RE: Bear Creek Canyon Portal
Emery County, Utah
ACT/015/025

The Division staff has completed its review of the plans submitted for the Bear Creek Canyon Portal. The Division is prepared to approach the Board of Oil, Gas and Mining for the issuance of tentative approval under the interim regulatory program provided, however, that the following stipulations are agreed upon.

Figure 40. Coal and geology map, Hiawatha NE quadrangle (explanation pages 136-137).

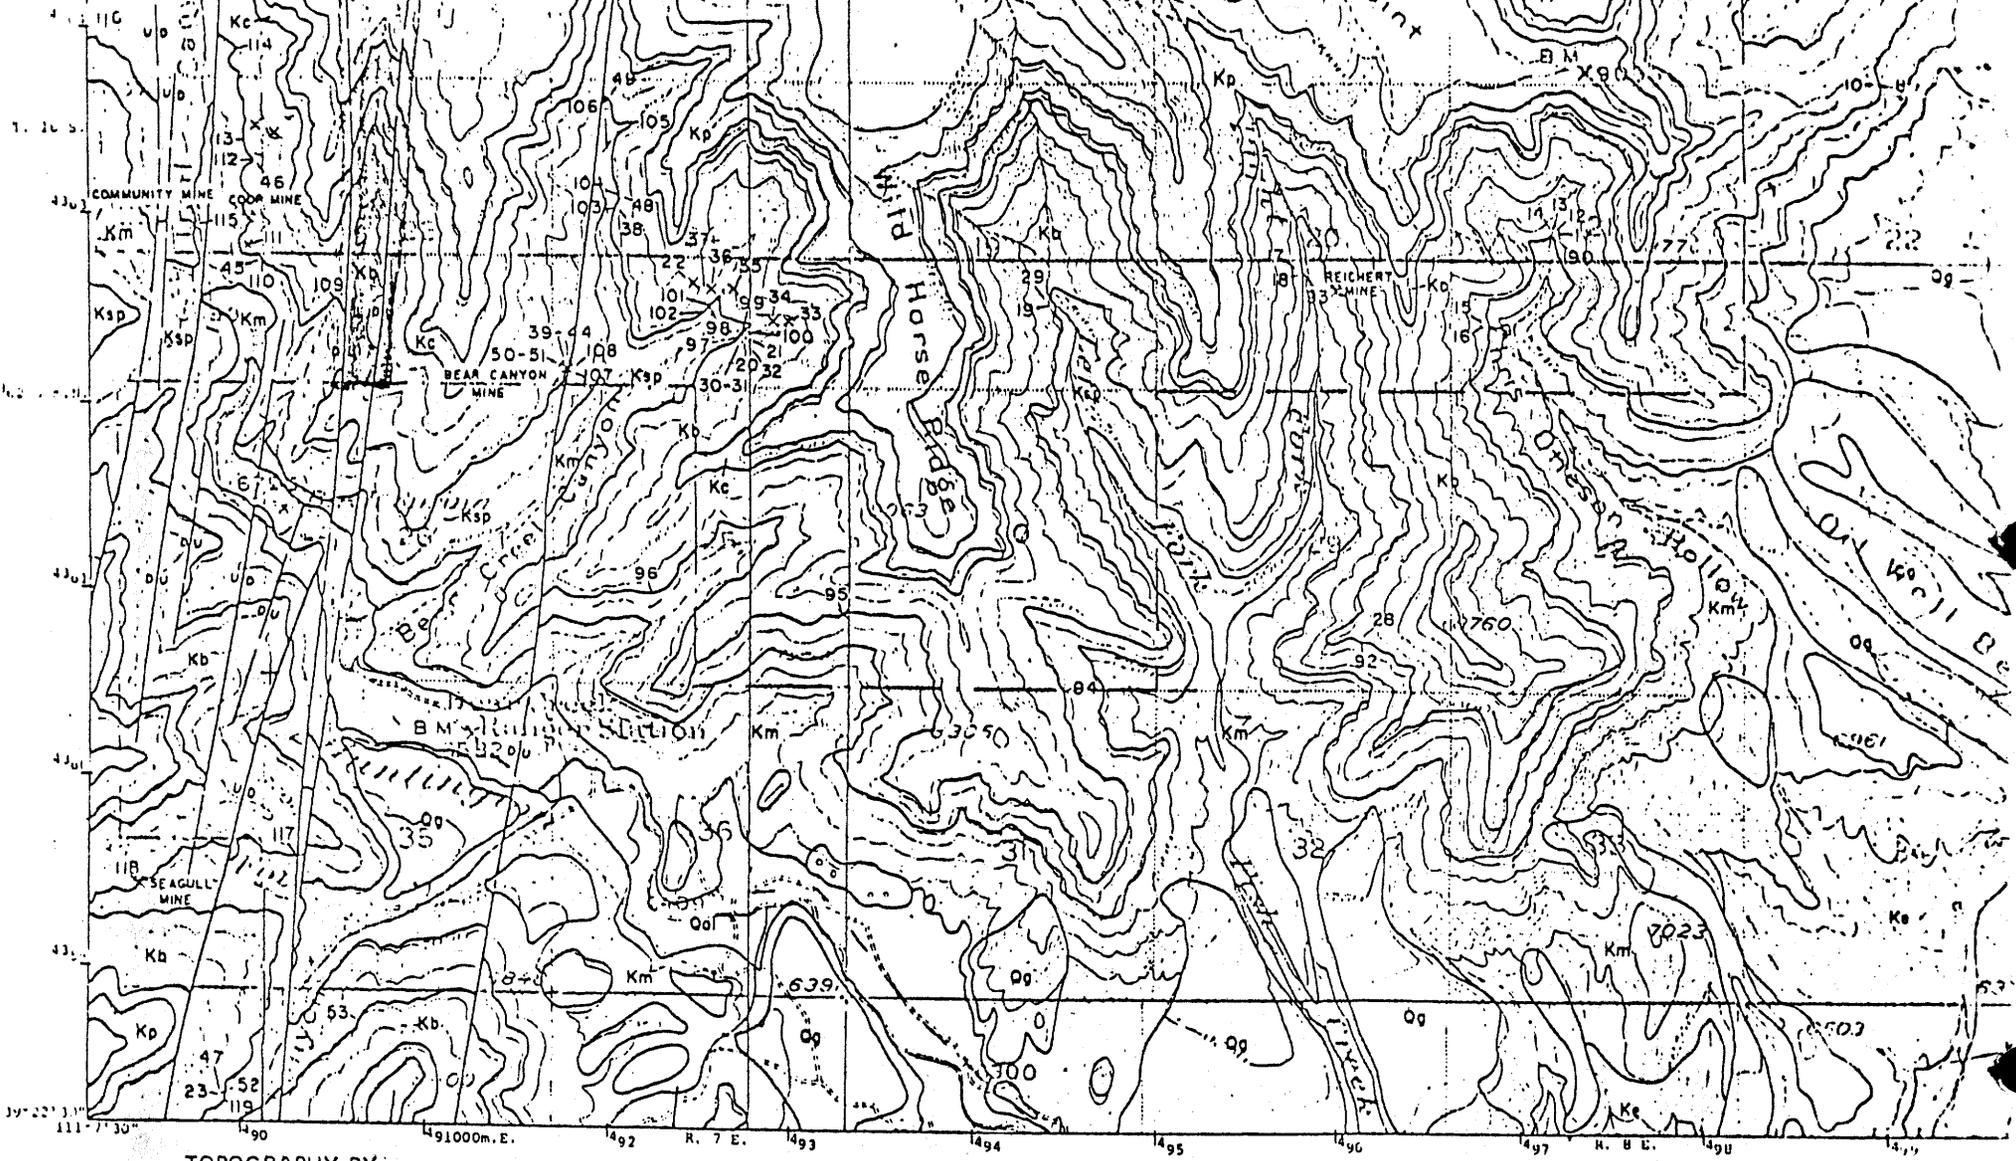
1. Mining will not occur within 100 feet on either side of the two major normal faults that cross the property, trending north-south. Consult the enclosed map.
2. Culverts shall be placed in accordance with the proposed permanent program requirements. A copy of the applicable requirements are enclosed for your reference. Any section of road that is used for coal haulage shall be designed, constructed and maintained as a Class I road. All other sections of road shall be designed, constructed and maintained as a Class II road.
3. The proposed road crossing of Bear Creek shall utilize culverts that will pass at a minimum 130 cubic feet per second with headwater no higher than the culvert intake. This requires either one 60 inch culvert, two 48 inch culverts, or three 42 inch culverts.
